# MIL-I-18804B

Amendment-1

### INDICATOR. VERTICAL SPEED, 0-6000 FPM, 2-INCH

FIGURE 2. DIAL MARKINGS FOR MS28075-1 (B) and MS28075-2 (B)

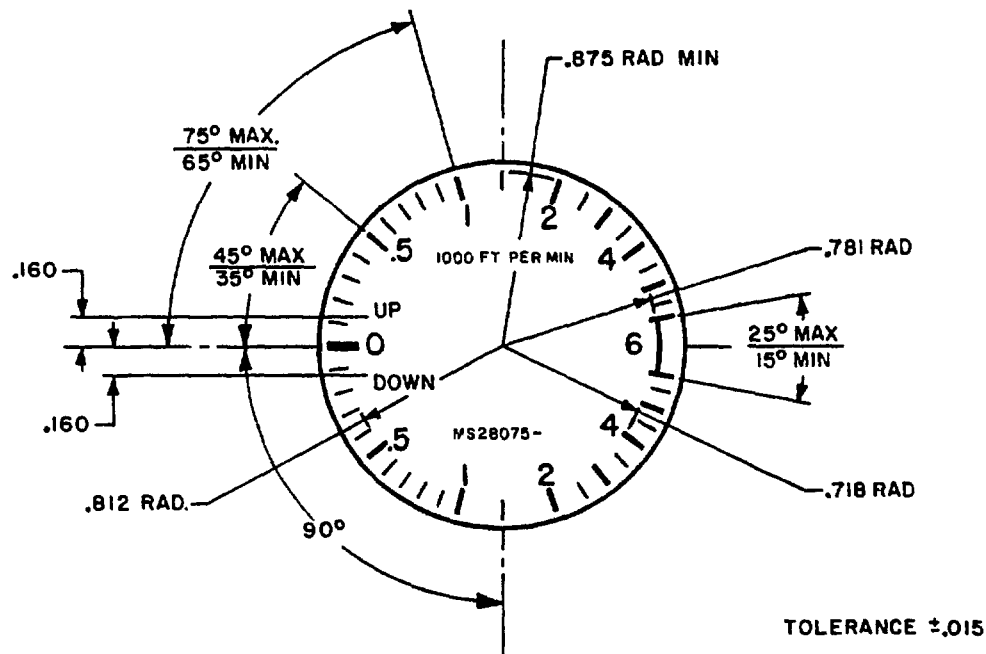
Add Figure 2 "Dial Markings for MS28075-1(B) and MS28075-2(B)" after Figure 1, page 6. Figure 2 forms page 3 of this Amendment.

Page 9, paragraph 4.6.7.1: Delete fourth sentence and substitute "The pointer shall return to zero within 250 FPM in both directions for the Figure 1 dial, and within 150 FPM in both directions for the Figure 2 dial".
